PLANNING COMMISSION WORK SESSION MEETING

1. SUP 2022-05 Warrenton Village Center, the Owners, Jefferson Associates LP and Warrenton Center, LLC with the Applicant, NewCastle Development Group, seek a Special Use Permit for two parcels totaling approximately 29.05 acres to create a mixed use development in the existing Warrenton Village Center. The proposal includes apartments, 2 over 2s, and townhomes with the addition of central plaza, parking garage, enhanced internal road network, and pedestrian infrastructure to promote walkability. The properties are zoned Commercial and designated in the New Town Character District of Plan Warrenton 2040. (GPINs 6985-20-7247 and 6984-29-6753)

STAFF REPORT

| Agenda Title: | Special Use Permit 2022-05 Warrenton Village Mixed Use |

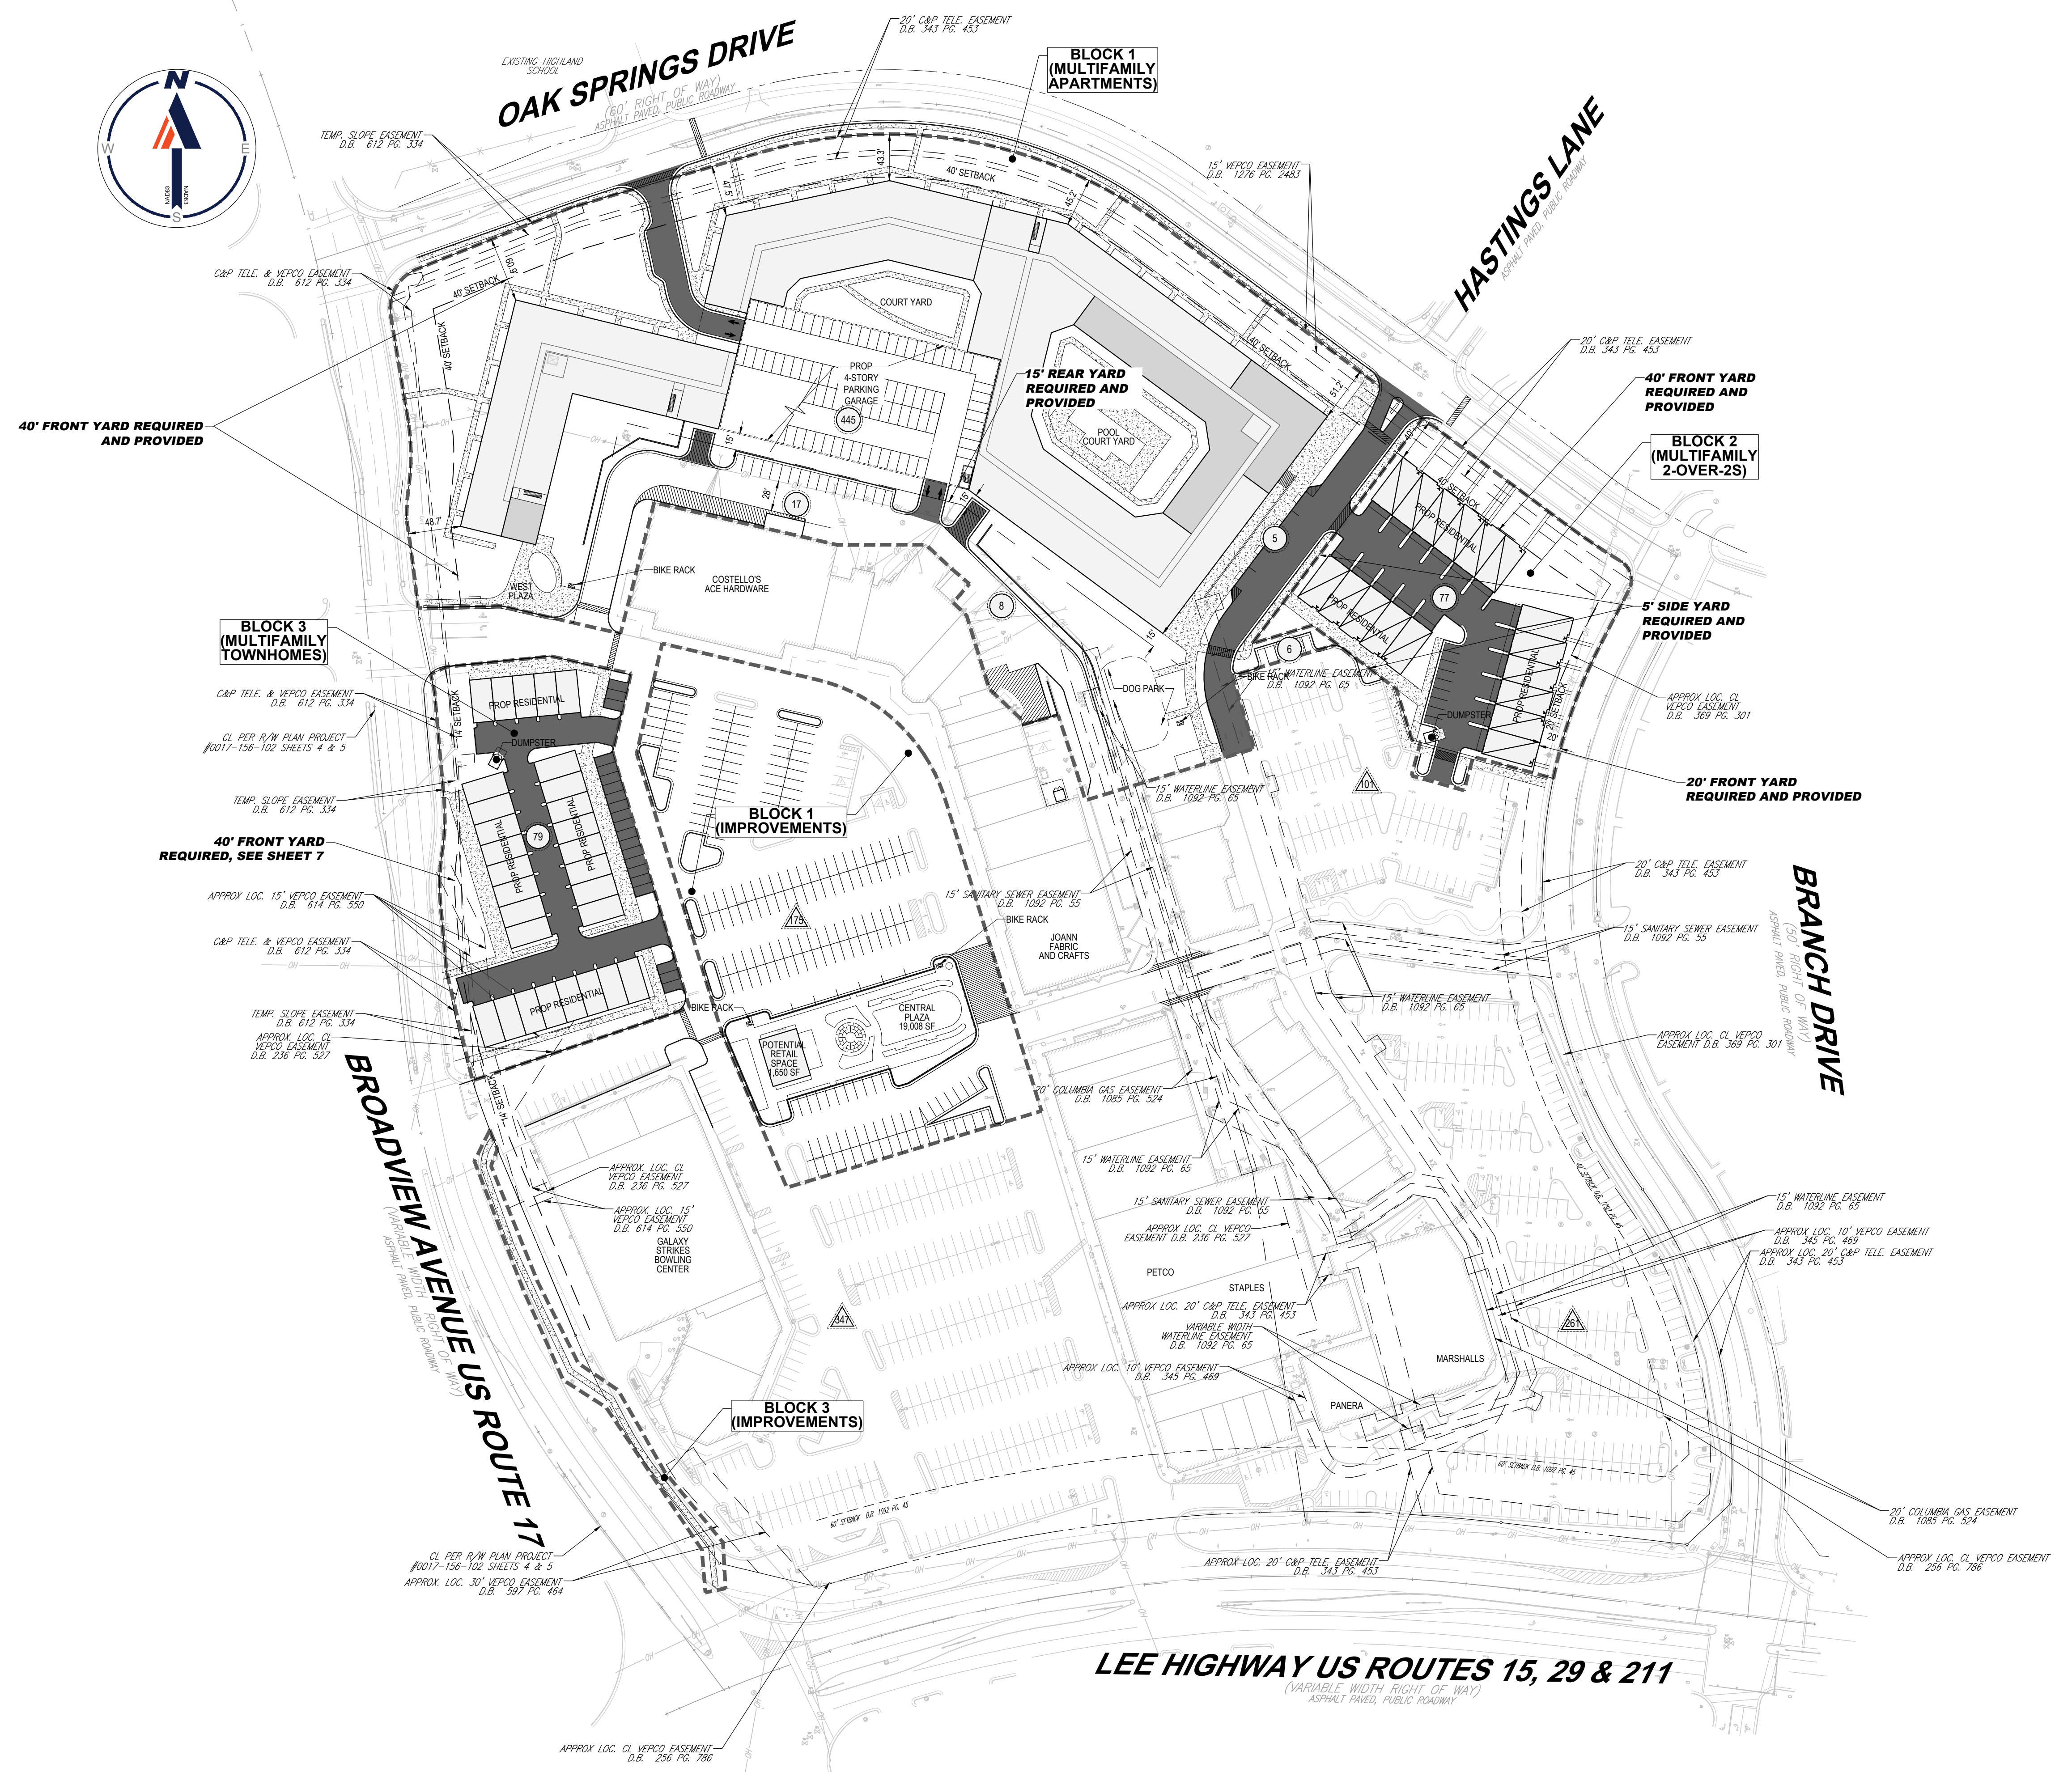
| <p>Provide a separate sheet showing the existing and proposed parcel boundaries, to include existing/proposed building footprints and required setbacks from property lines.</p> | <p>Sheet 2A "Parcel Overview Plan" has been added to the SUP to address this comment.</p> |

CONCEPTUAL SITE SIGNAGE PLAN

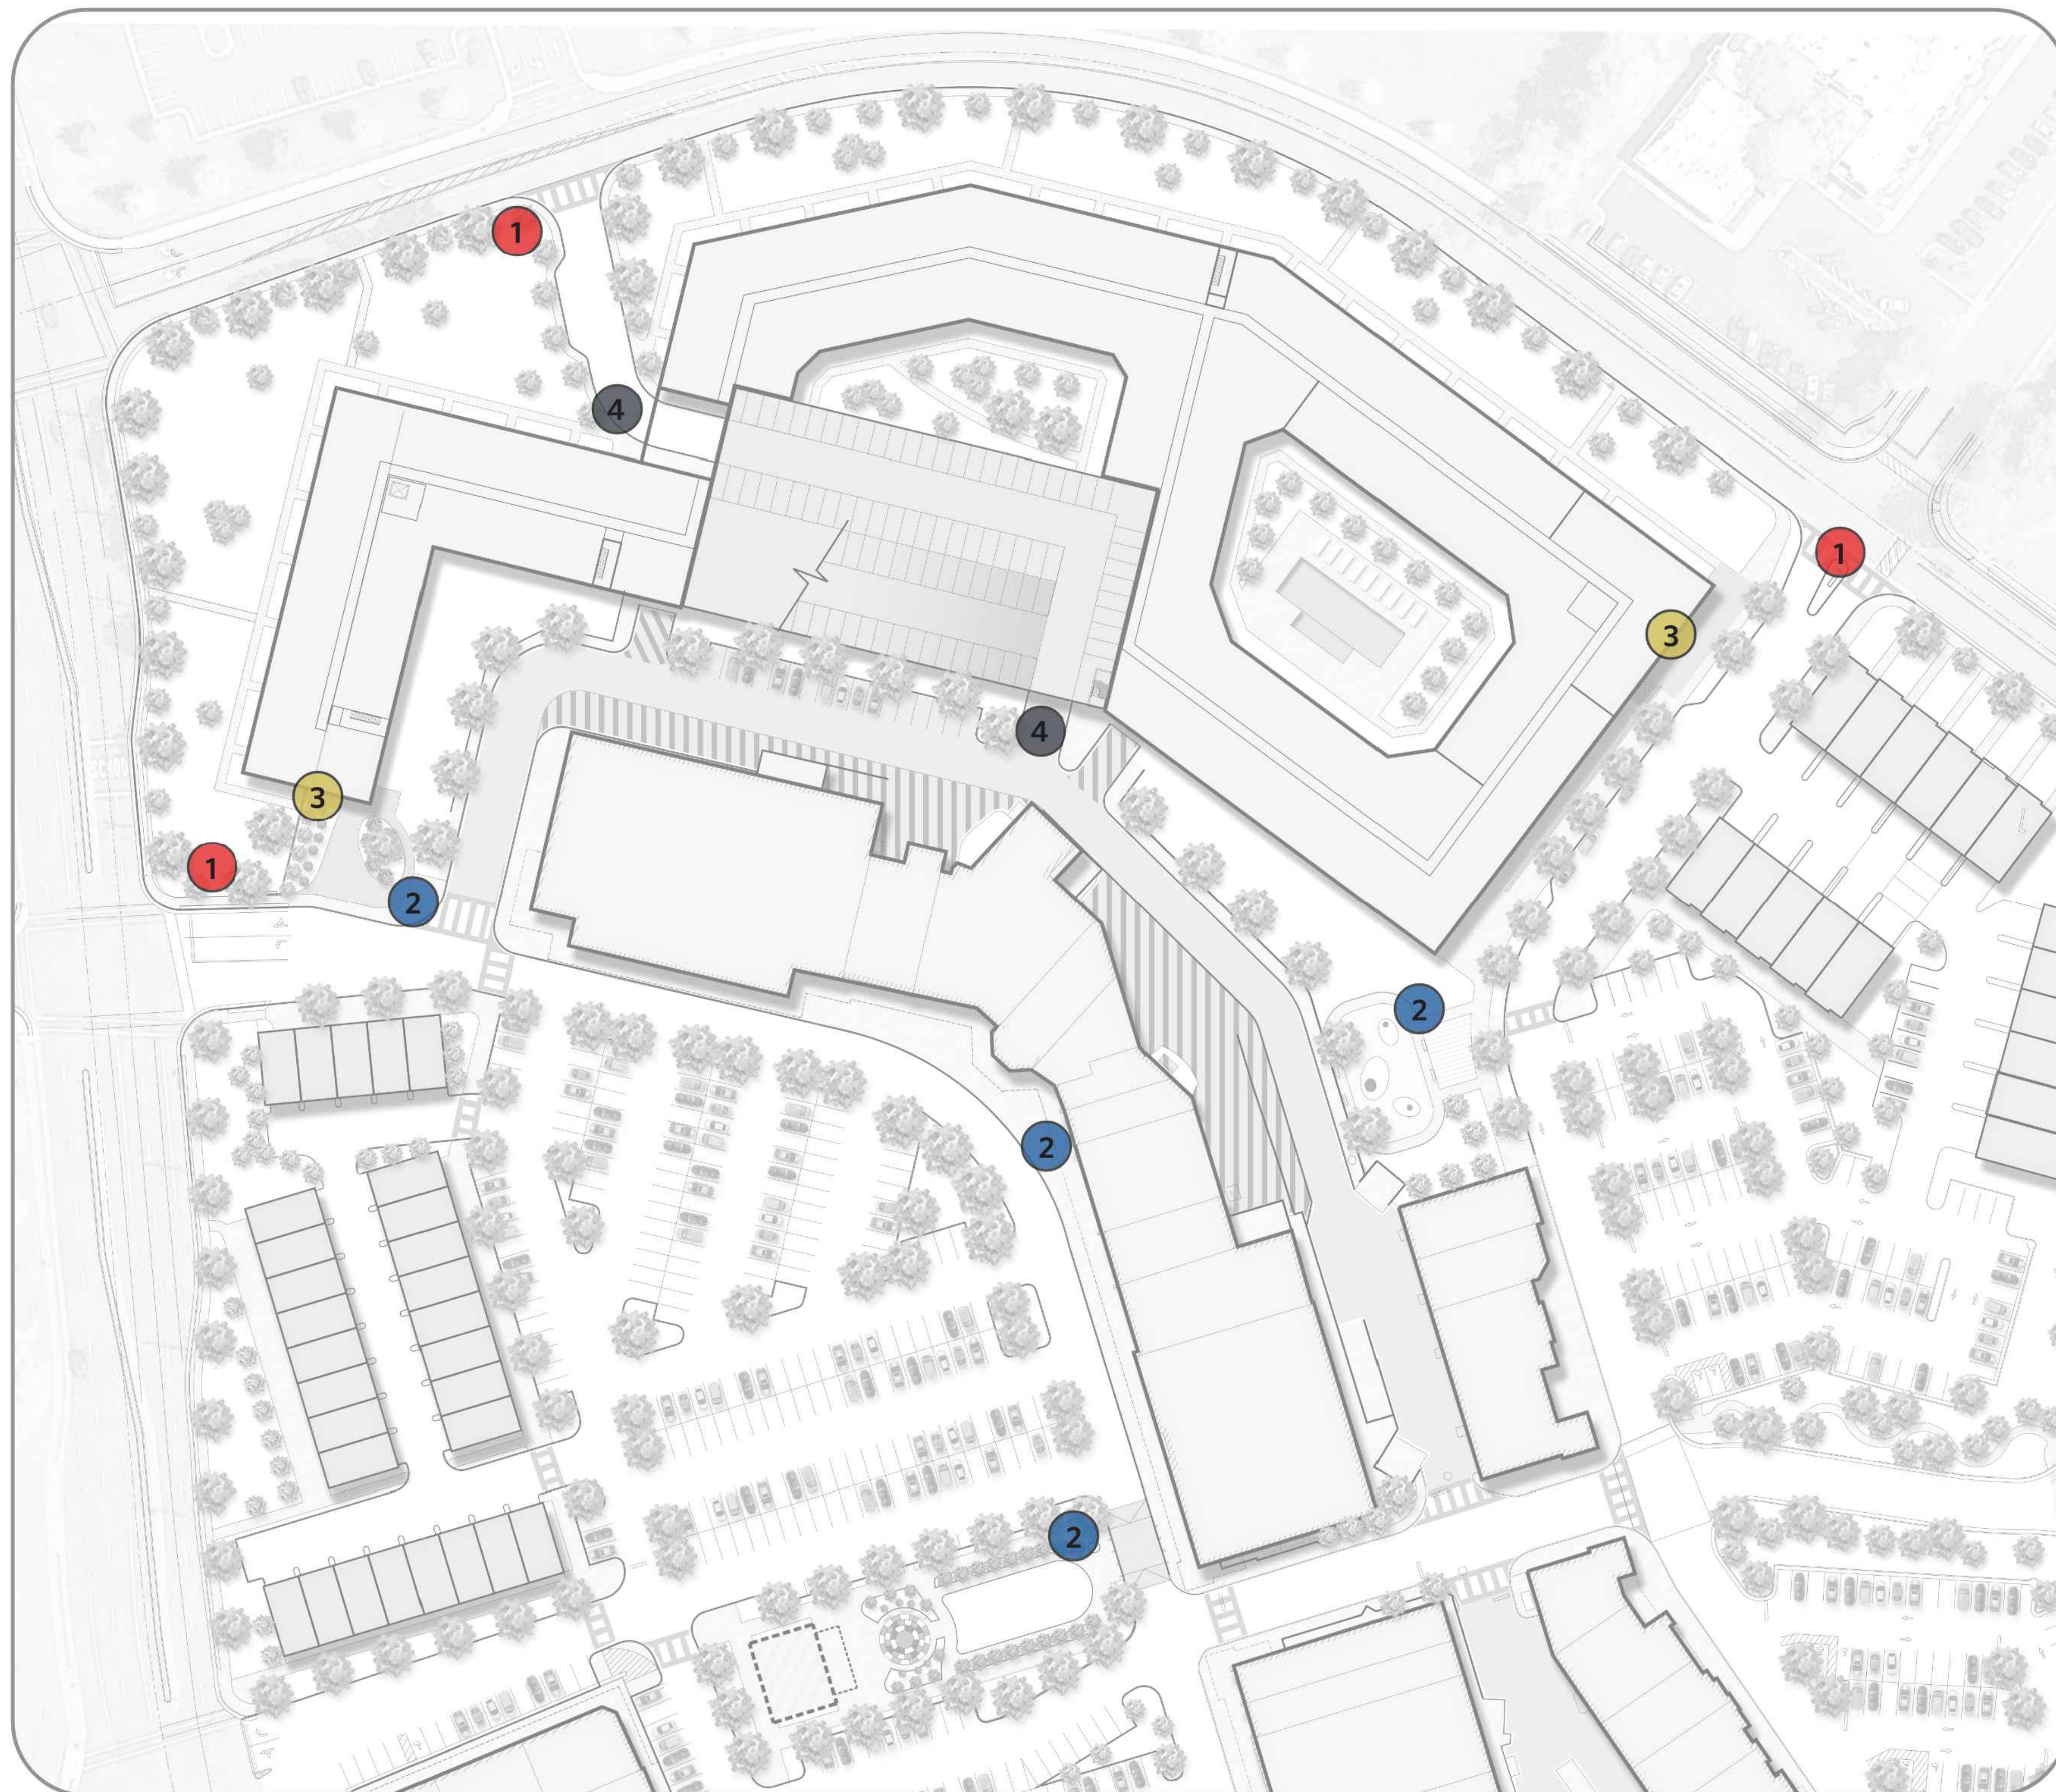
| <p>Conceptual building signage (#3) shown on Sheet 16 does not meet the Zoning Ordinance for Building Signage--"6-13.3.2; Building Signs shall not extend above the top of the roofline of the building to which it is attached."</p> | <p>Conceptual sign image #3 has been revised. Signs will be in conformance with all requirements of Article 6.</p> |
| <p>Conceptual monument signage depicted on Sheet 16 (#1) will be required to meet the requirements of Article 6-13.4 and will be subject to line-of-sight review during the Site Plan process; provide note to clarify requirement.</p> | <p>Note has been added to the Conceptual Signage Plan sheet.</p> |
